RFQ 2023-002-1007
Hellen Haller Elementary School
Fire Alarm Replacement

Sequim School District #323

ADDENDUM 1

Issued: March 24, 2023

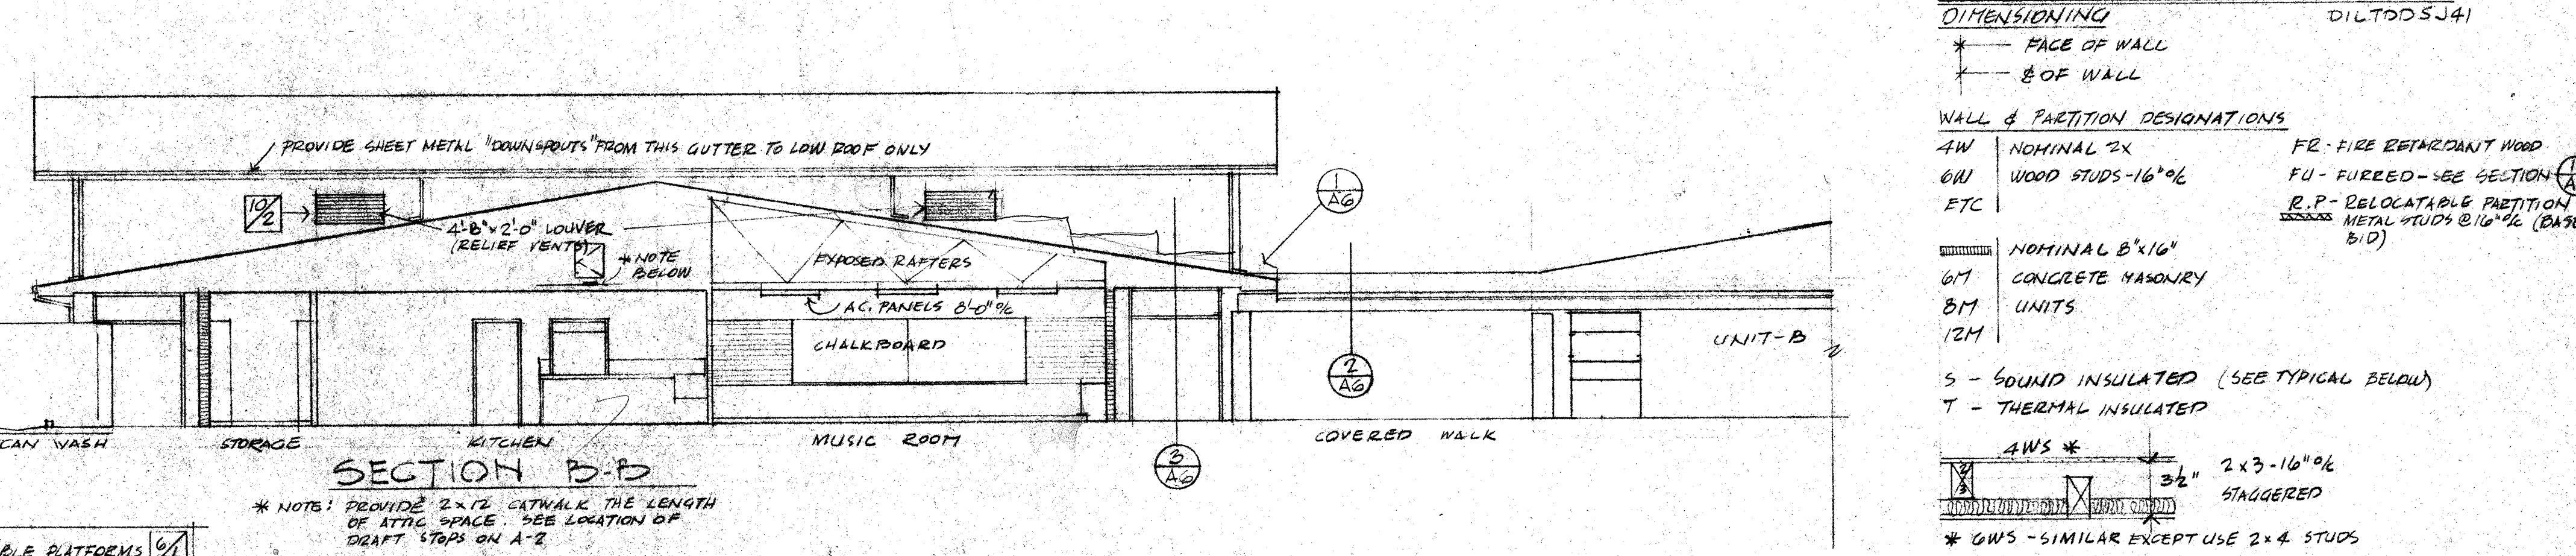
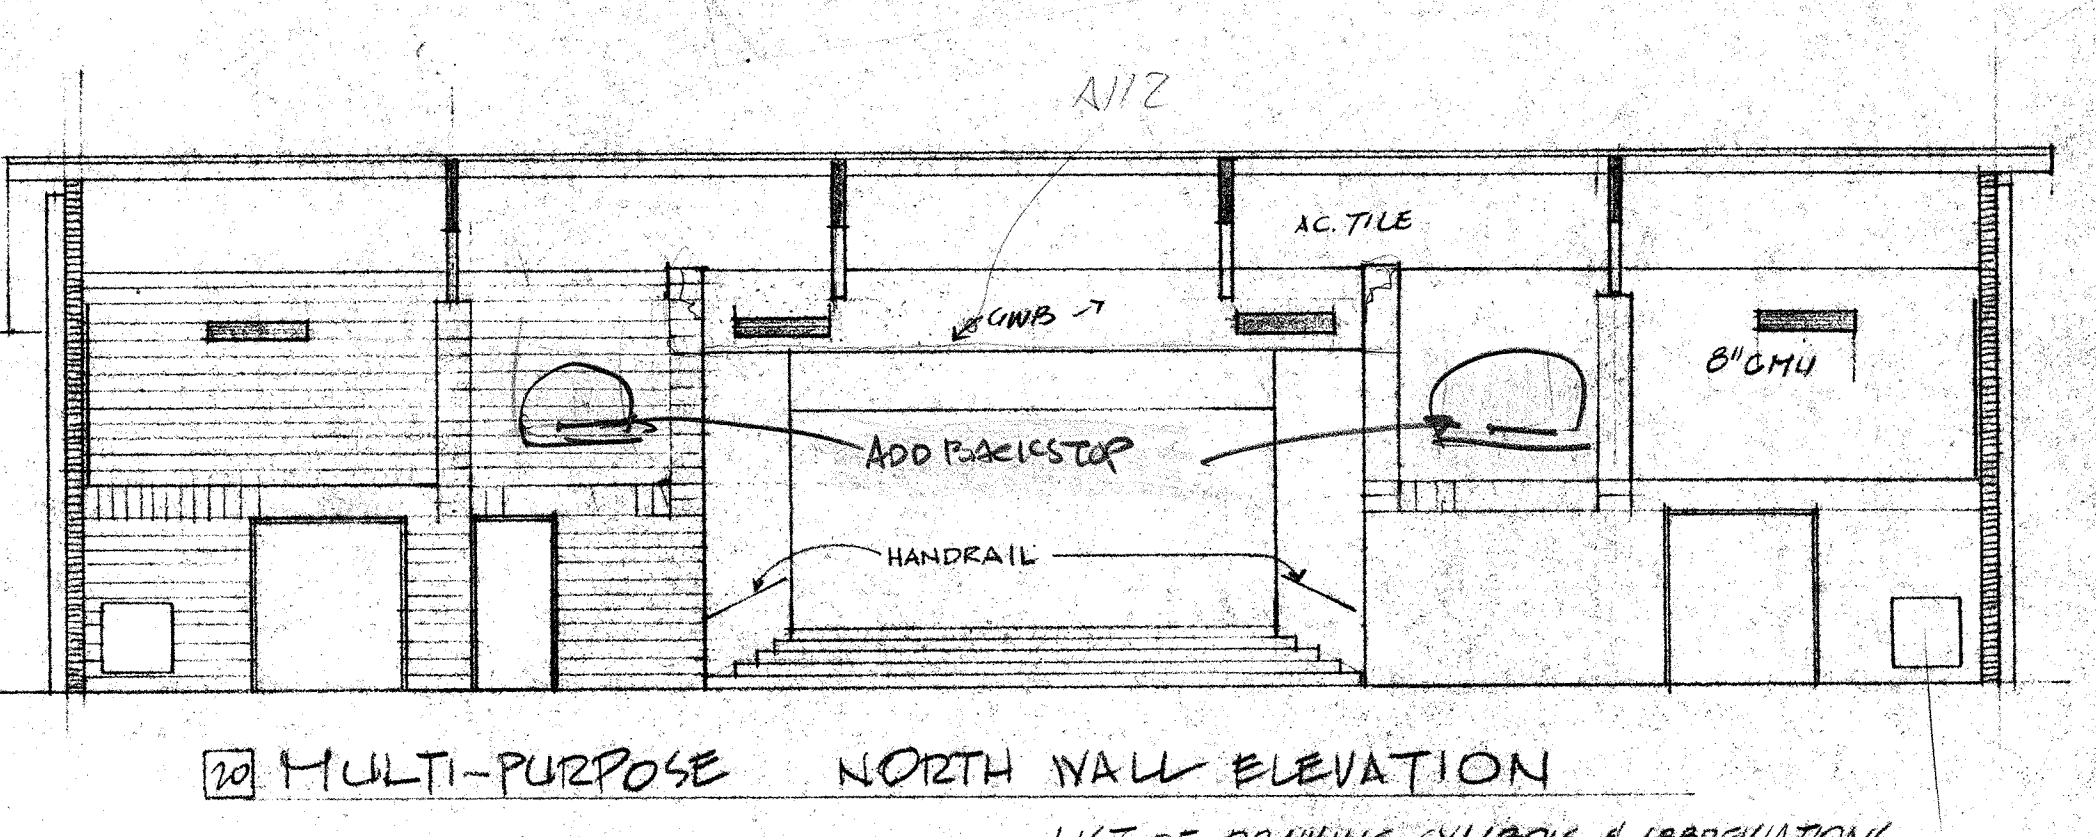
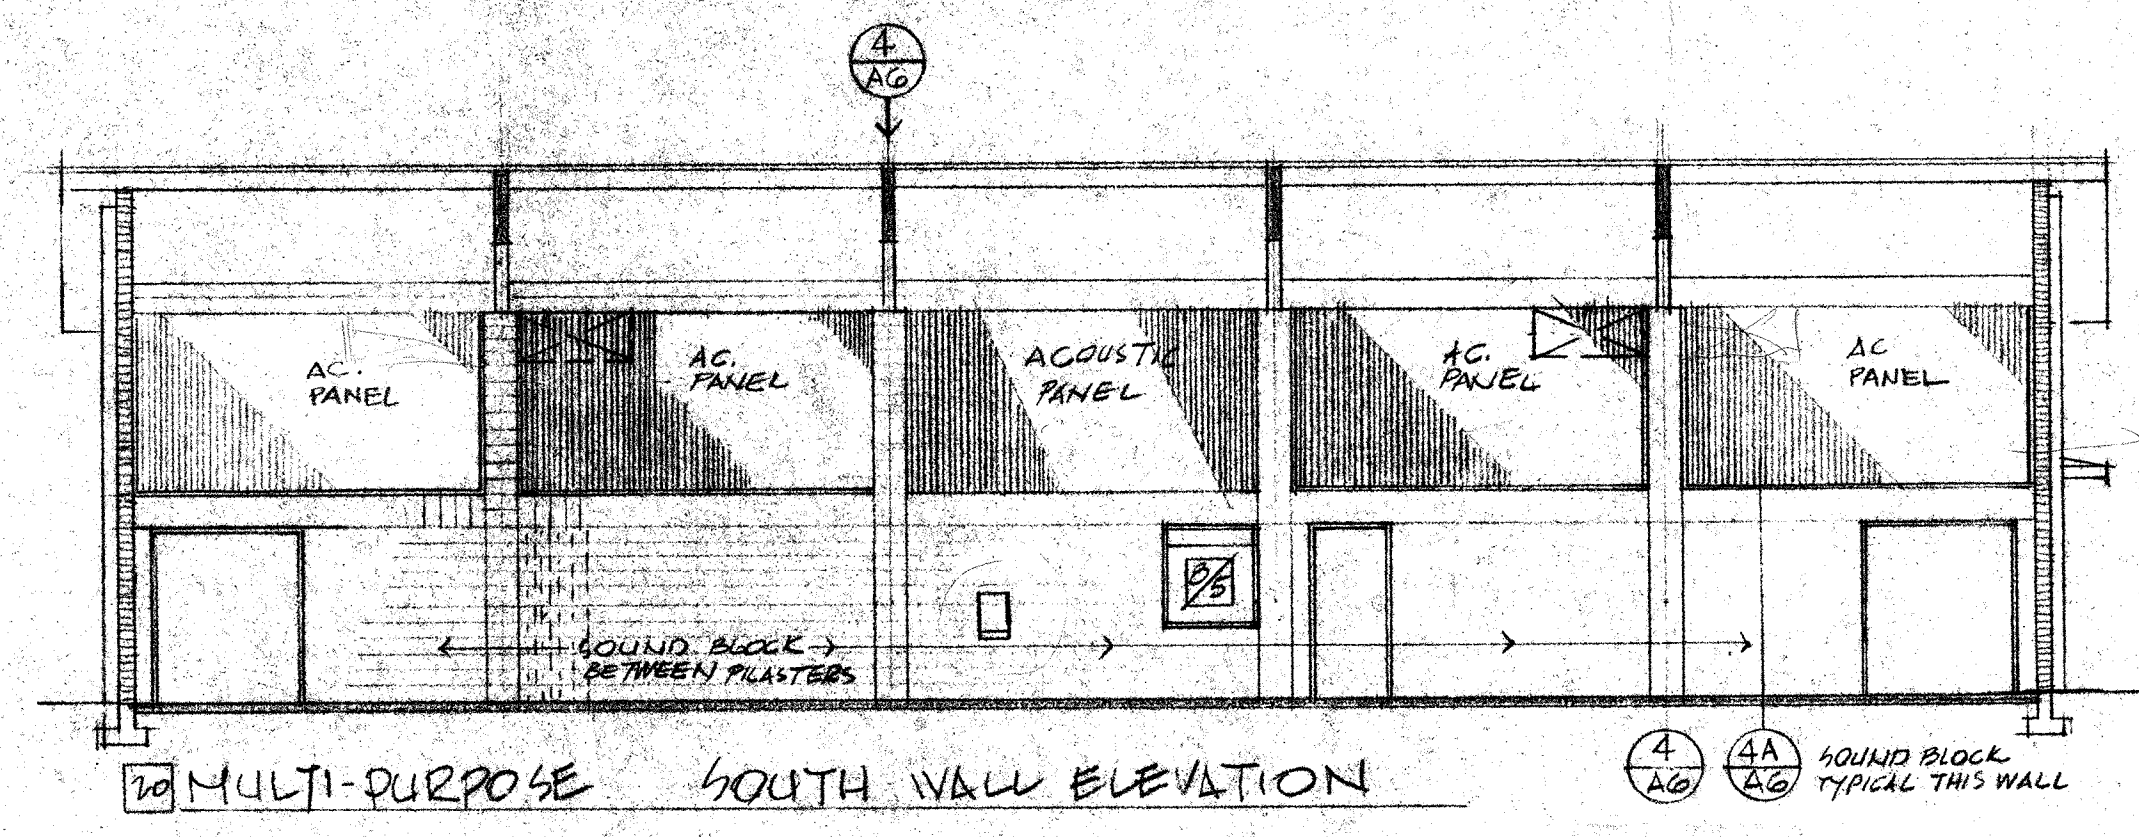
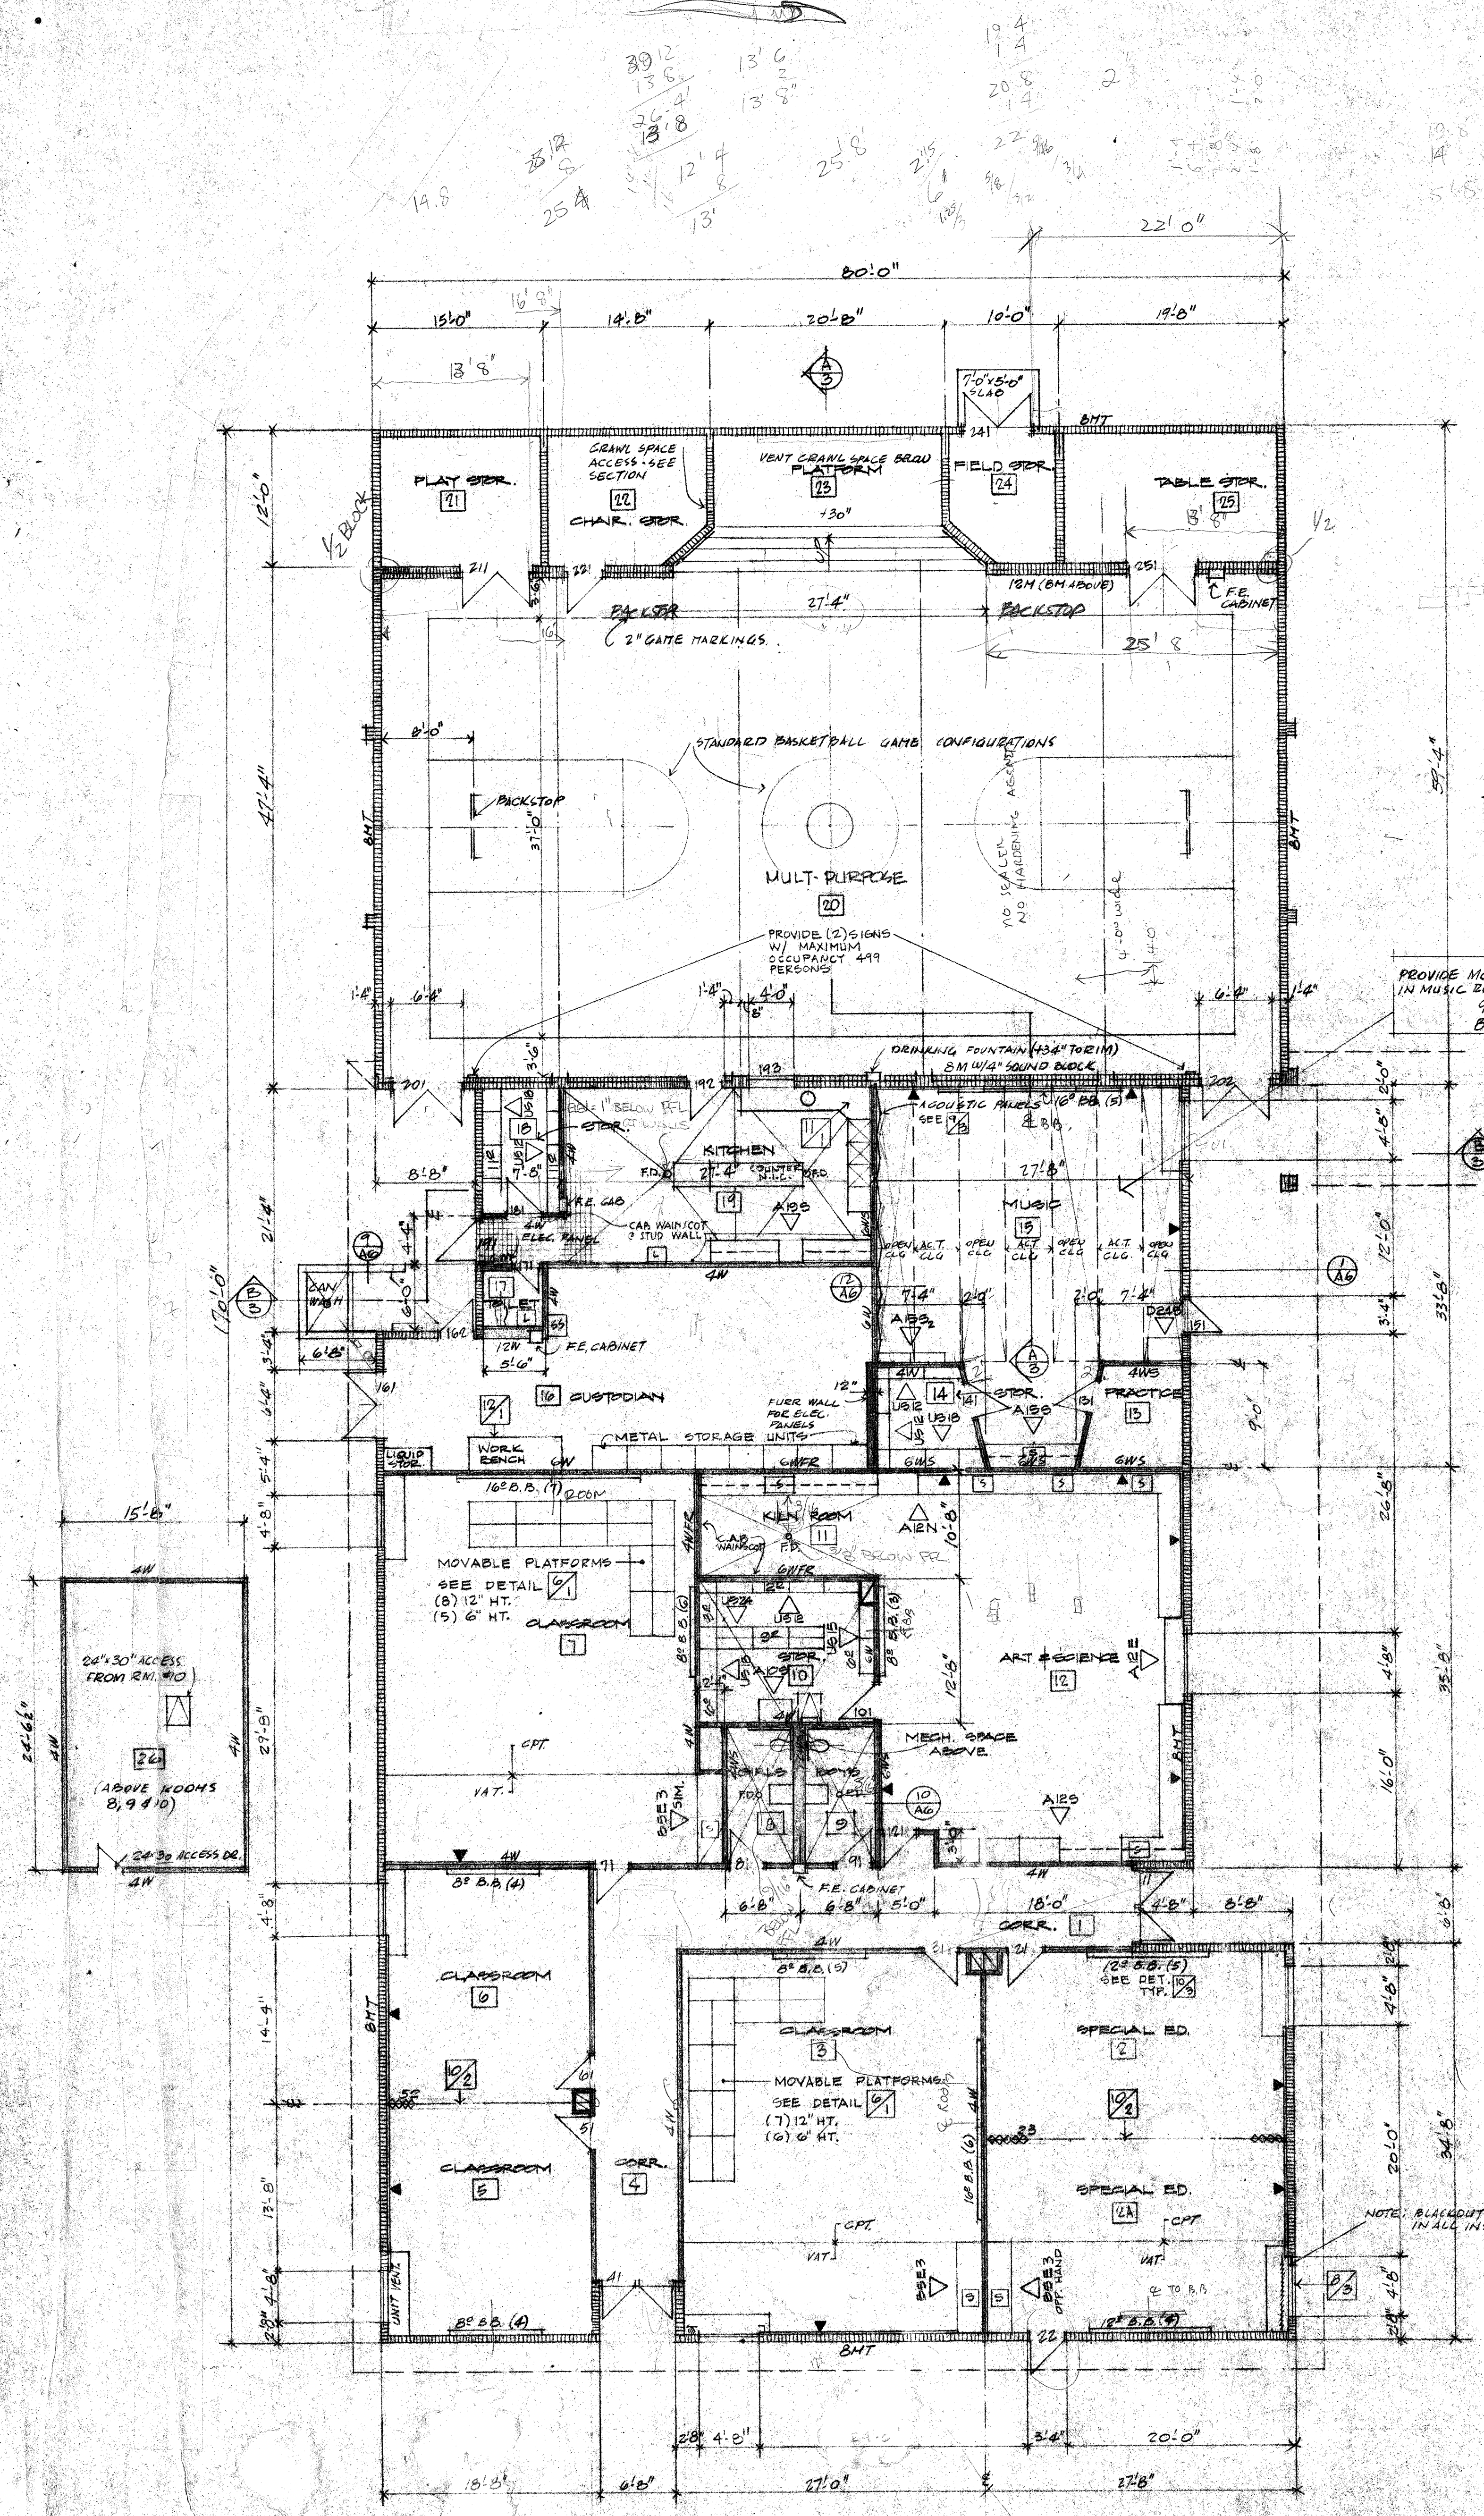
DRWG A3, Section A-A, delete mat rack shown and substitute the following: Two pairs of mat hangers - Porter No. 00142-000 with wood wall pad. Locate as directed by the Owner. Mount in accordance with Manufacturer's instructions.
